Re: Letter of Introduction for The Aurora Highlands Site Plan No.21 / Filing No.21

THE AURORA HIGHLANDS SITE PLAN #21

RE: Transportation Impact Study - Revised
The Aurora Highlands – Planning Area 70 (Century)

MOTOR COURT - TYPICAL LOTTING SETBACKS AND EASEMENTS
SCALE: 1"=20'

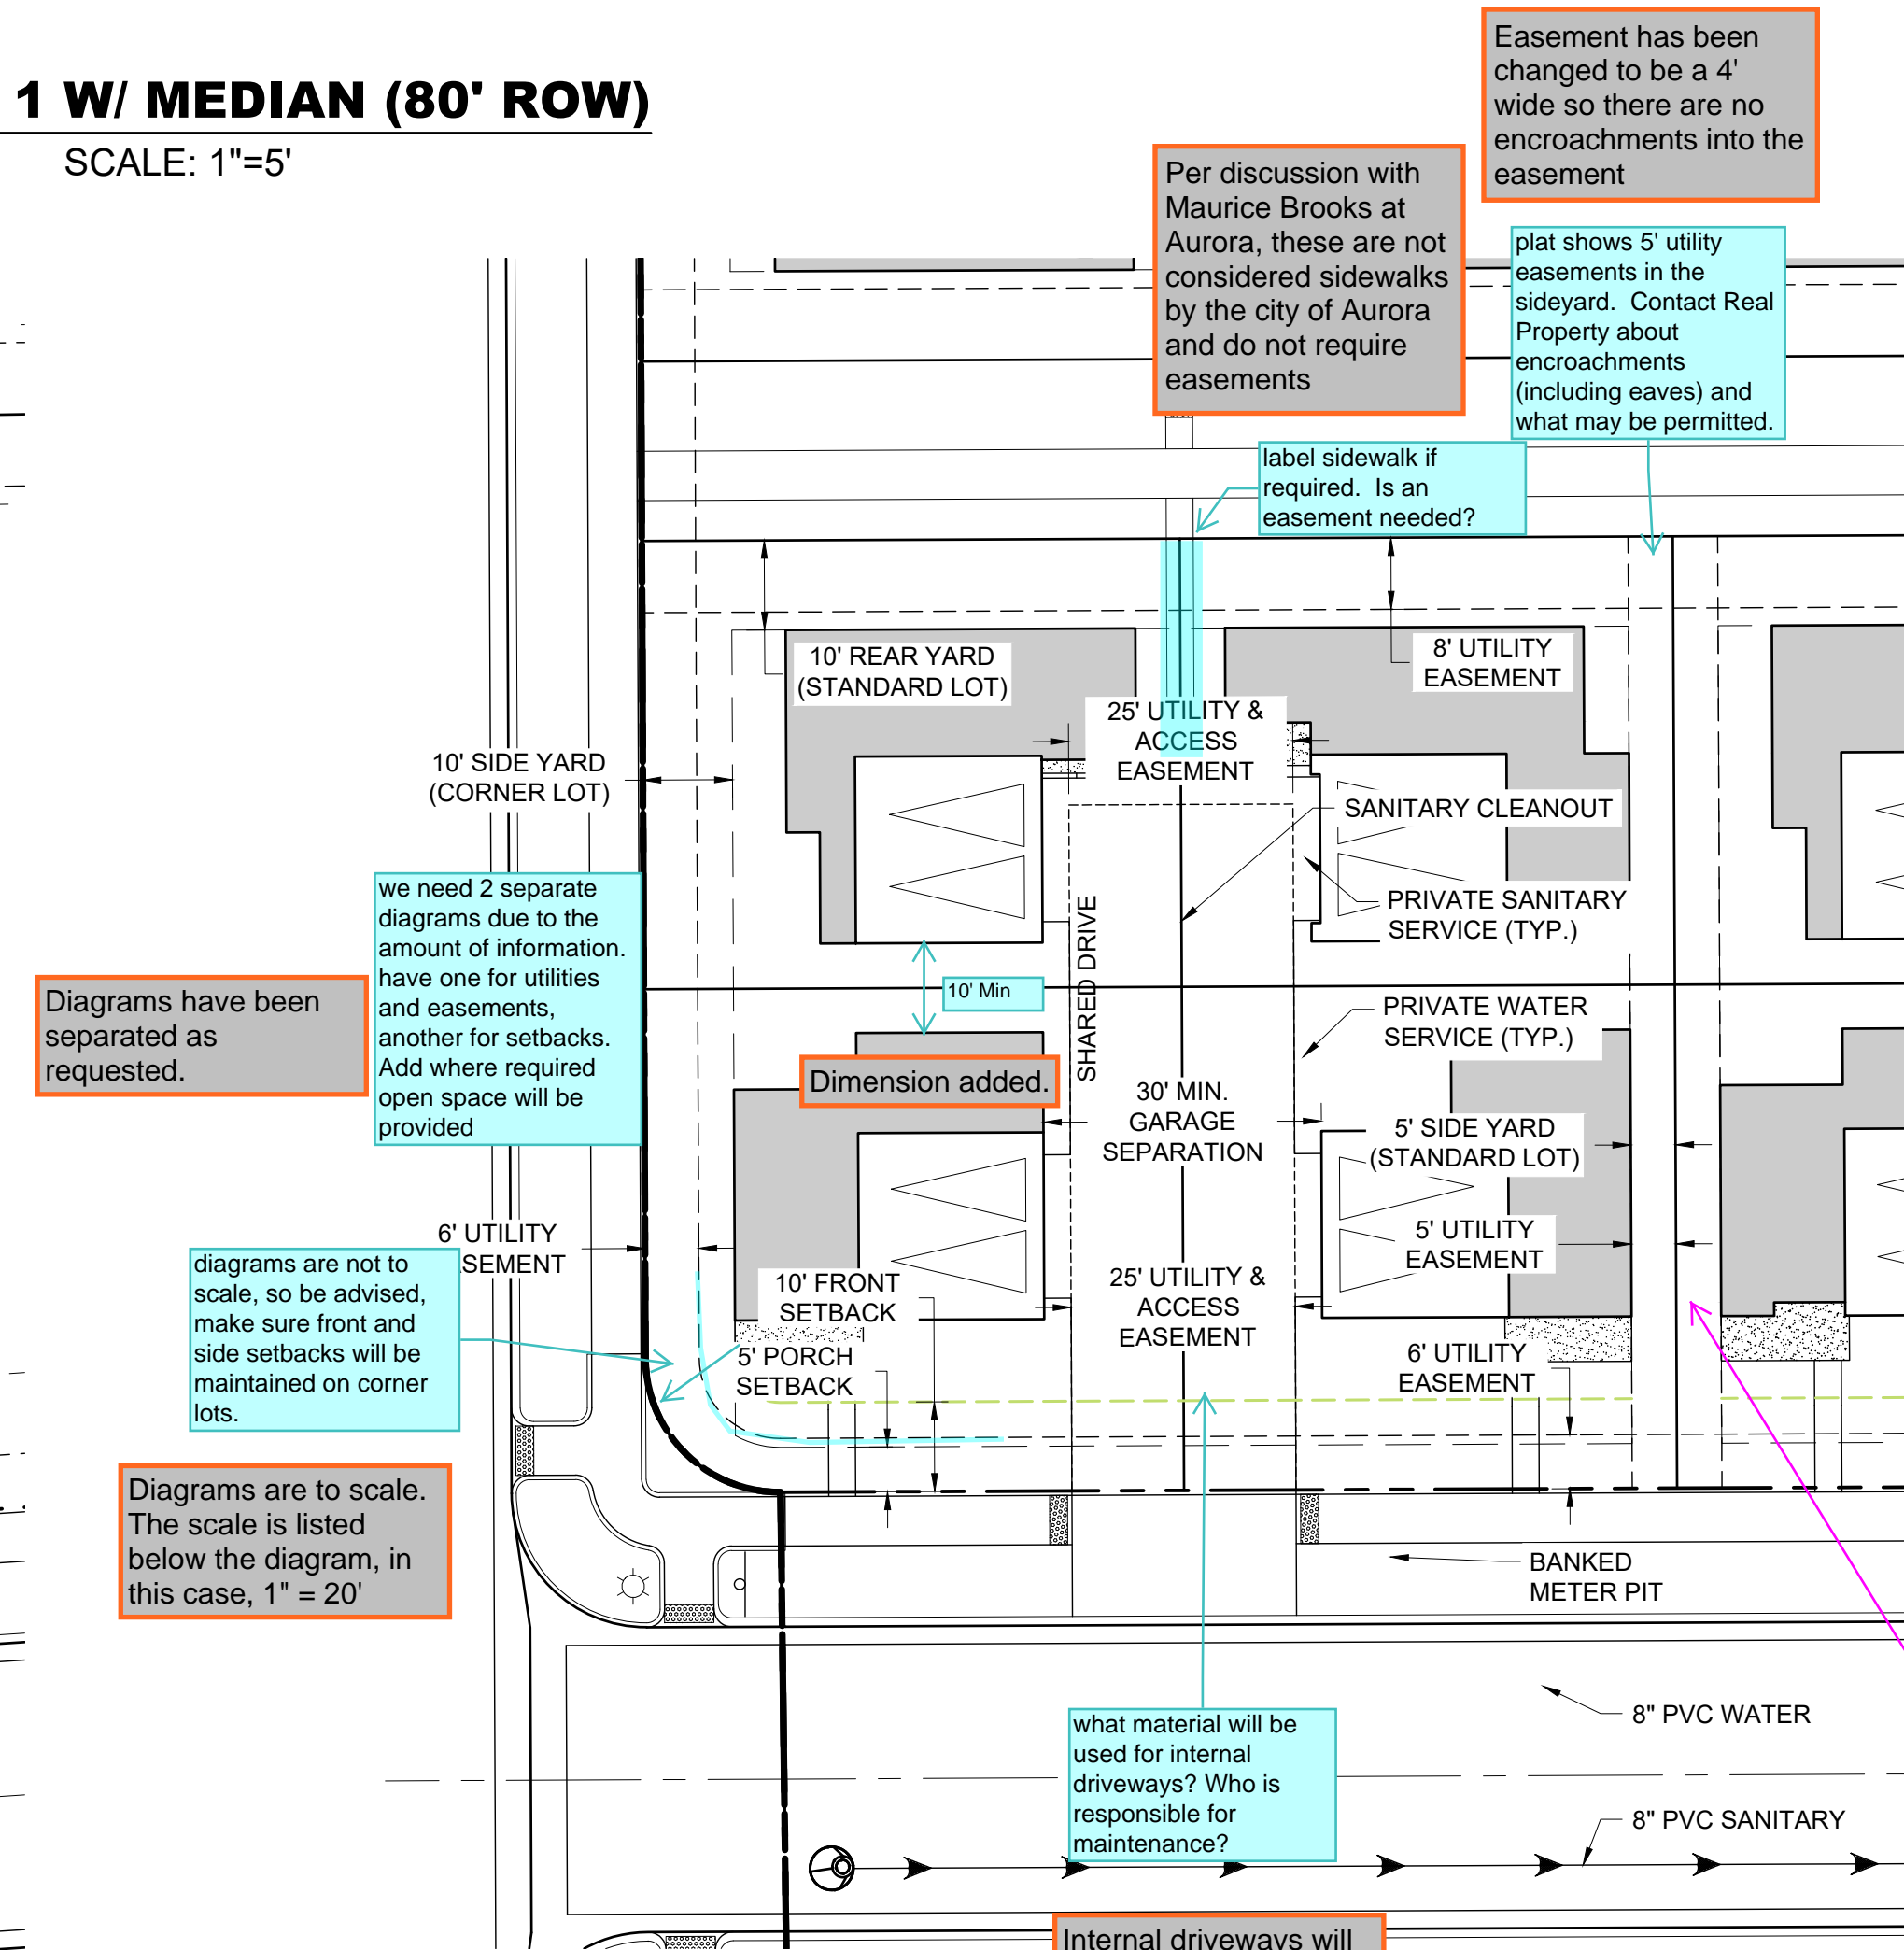
we need 2 separate diagrams due to the amount of information, have one for utilities and easements, another for setbacks. Add where required open space will be provided

THE AURORA HIGHLANDS SP#21
TITLE: GRADING AND UTILITY
PLAN
DATE: AUGUST 25, 2022

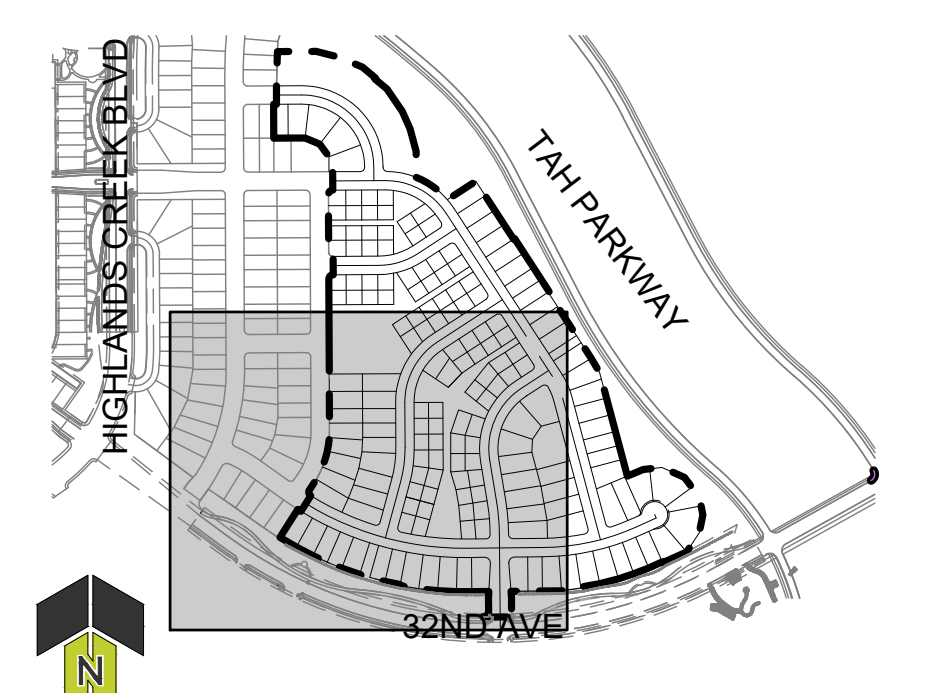
If possible, provide
connectivity between
trail along 32nd back
into the neighborhood.
this will otherwise
become a social trail
through the tract.

show sidewalk
connection to trail
6' G.E.

Elevation
change
across tract D
is too great to
add a trail.

TYPICAL LOT LANDSCAPE (MOTOR COURT)

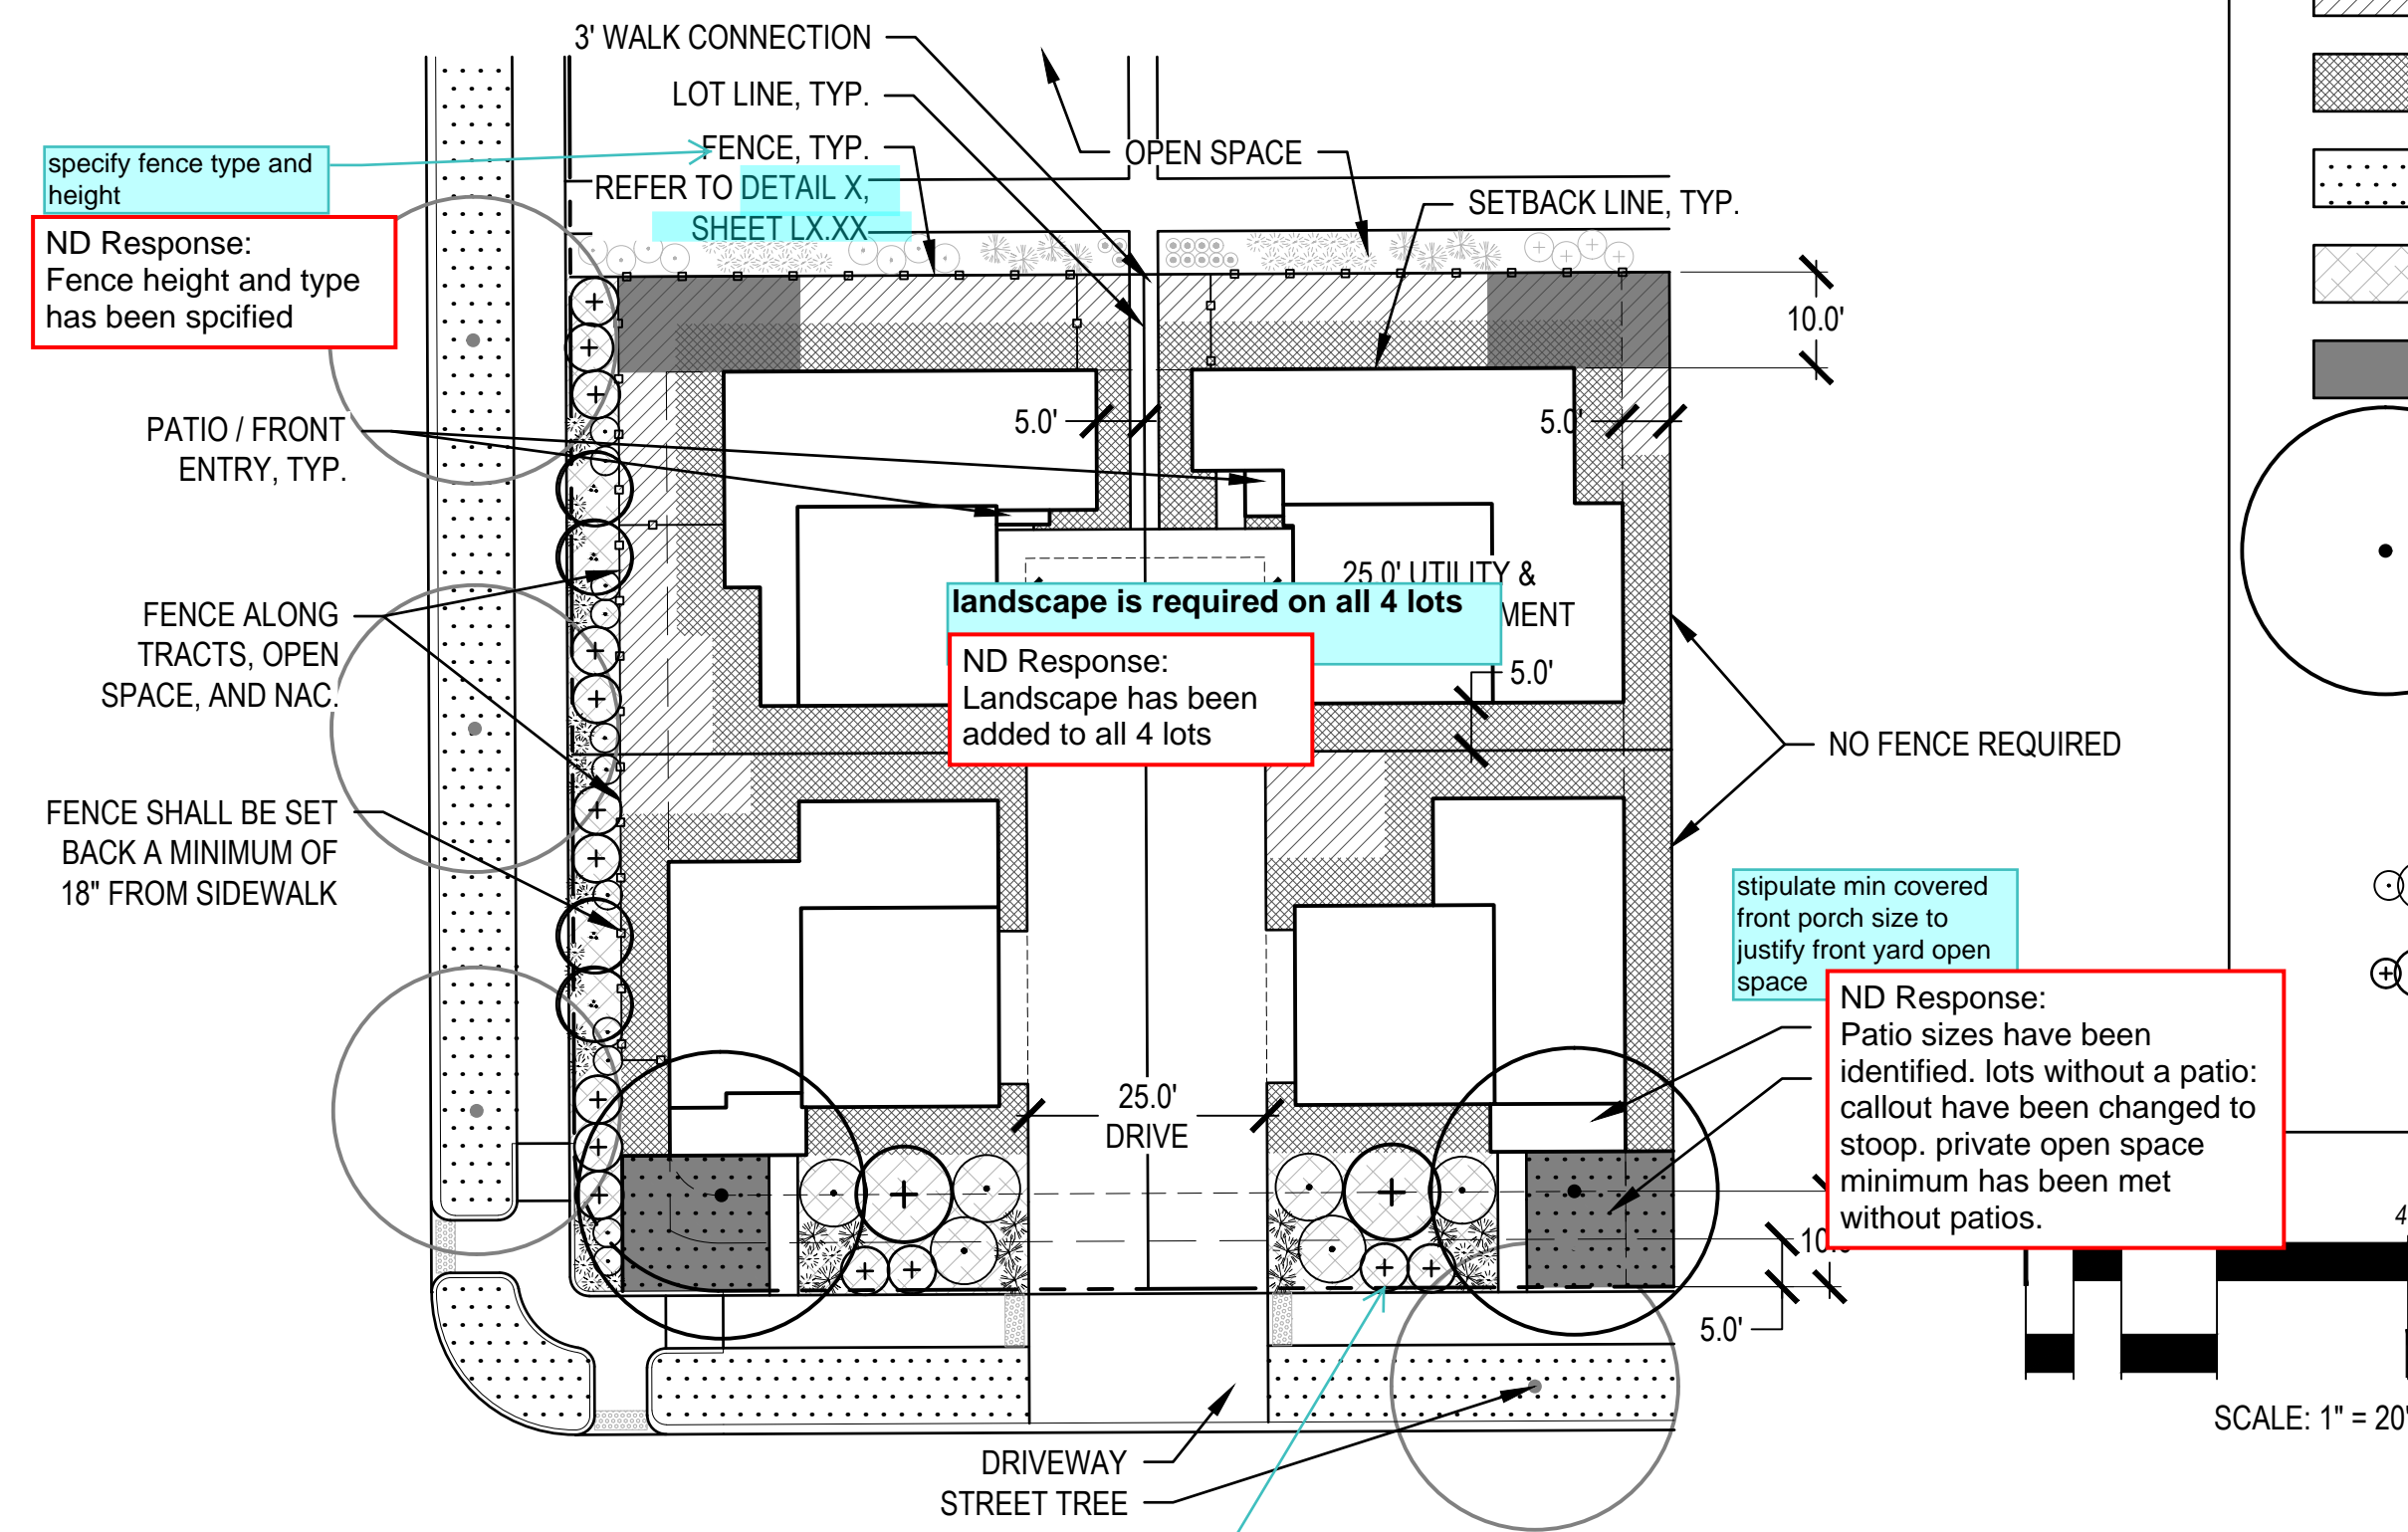
specify fence type and height

easements will limit what can be planted in front yard. Review code requirements and revise accordingly.

ND Response:
Fence height and type has been spcified

ND Response:
Easement added to the plan. Trees are not located within the easement.

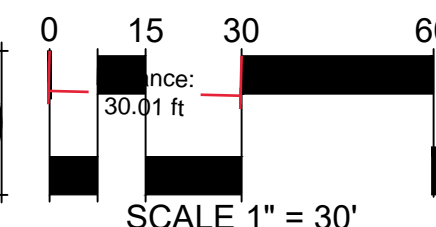
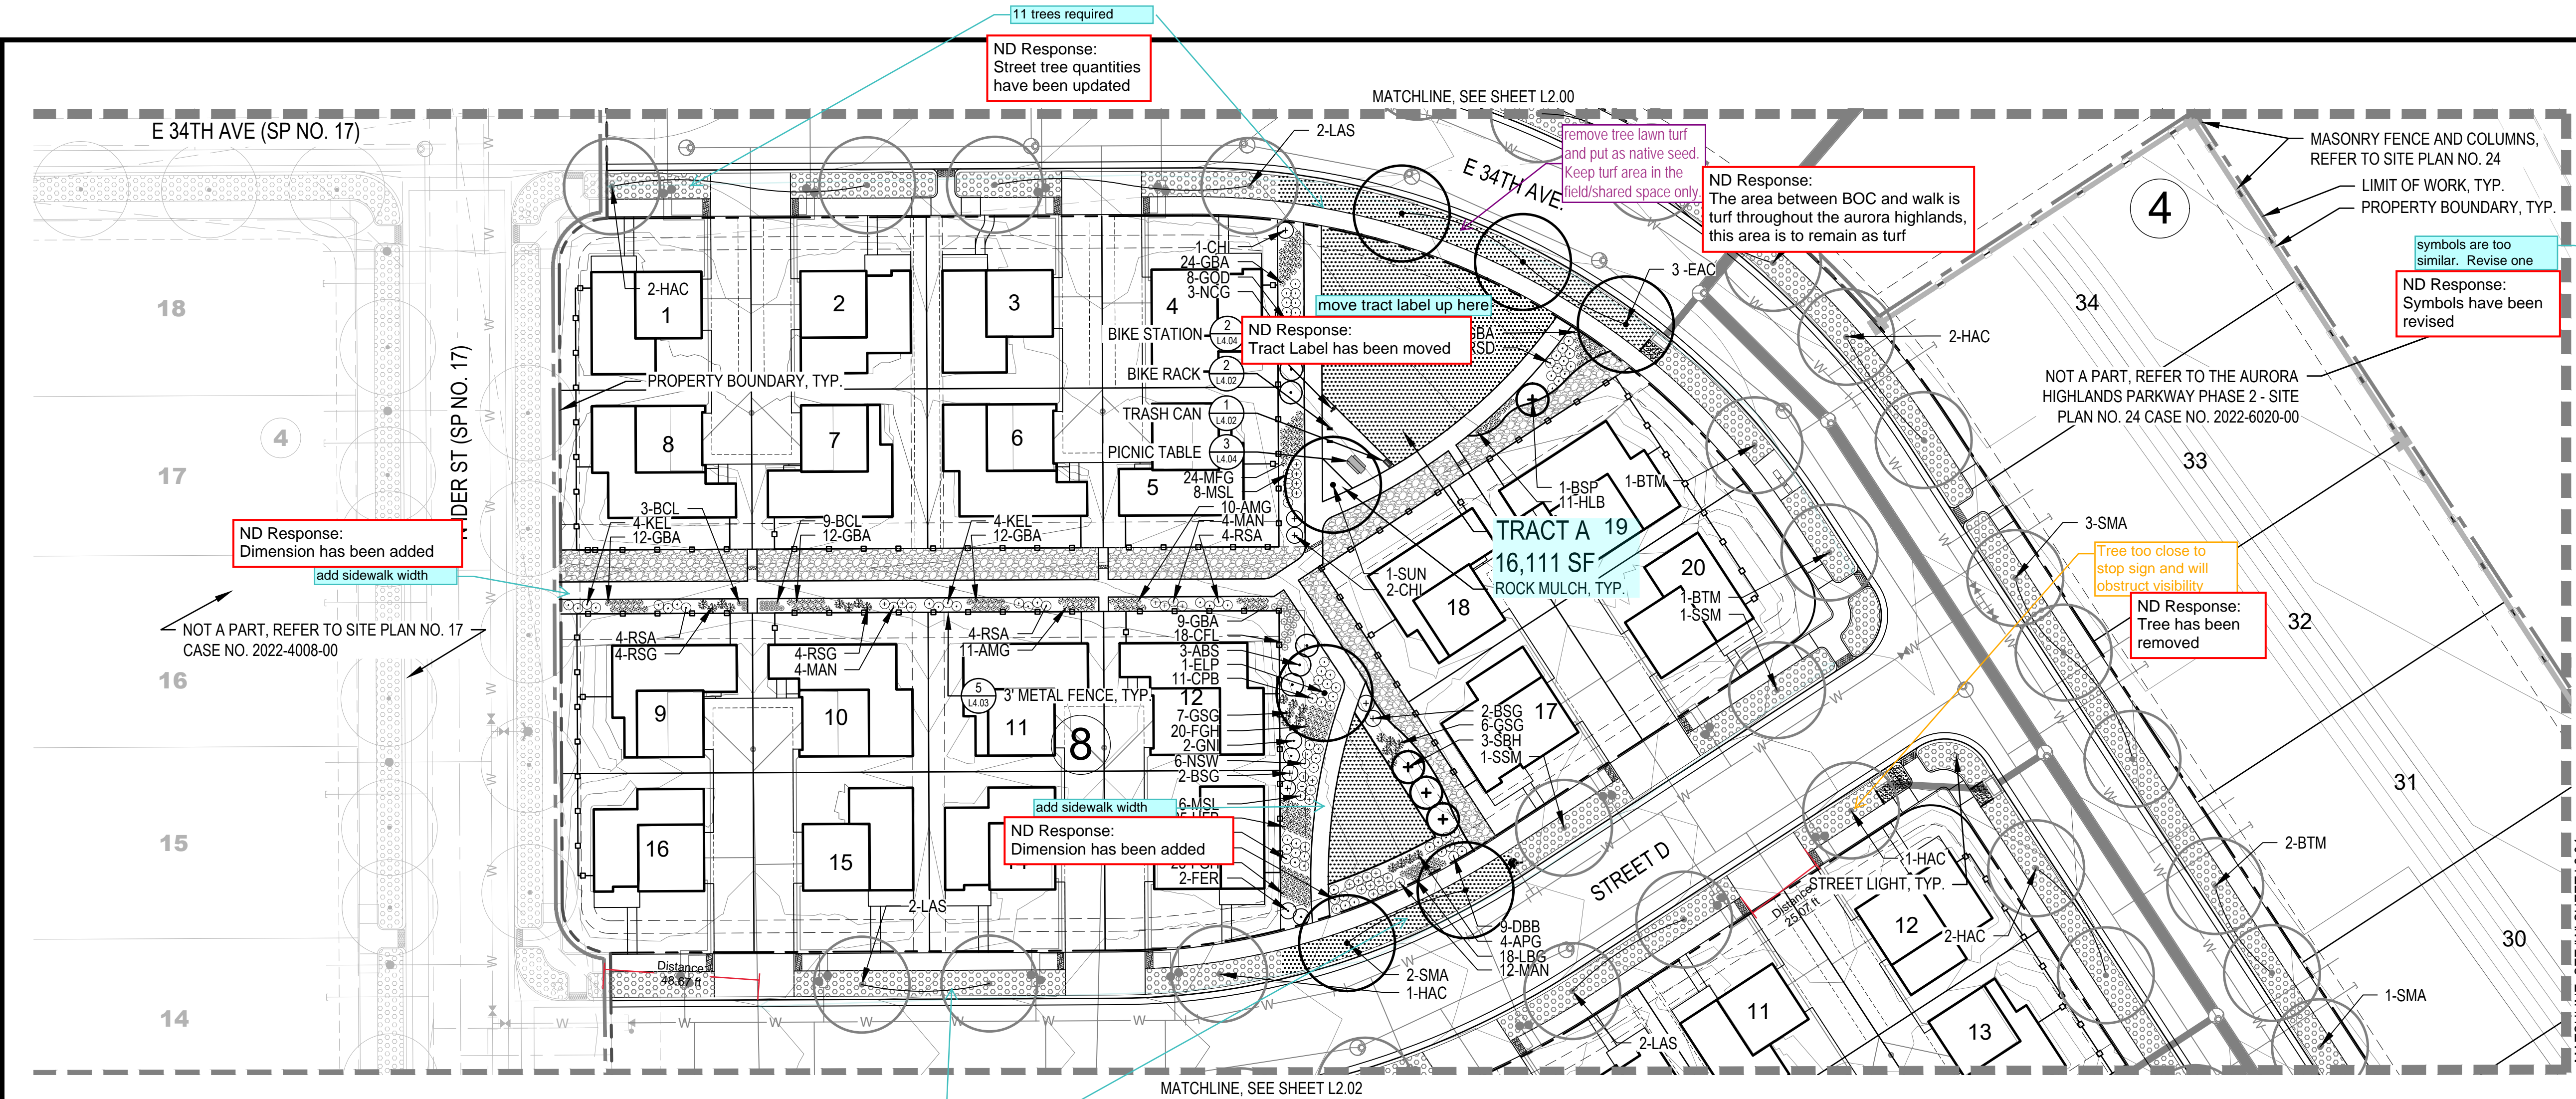
show lights and hydrants on plans.
Add mail kiosk to legend and show on plans.
TYP all sheets

darken symbol
ND Response:
Light symbol has been darkened

ND Response:
Lights and Hydrants are shown on plans. Mail kiosks are shown on plans and have been labeled and added to the legend.
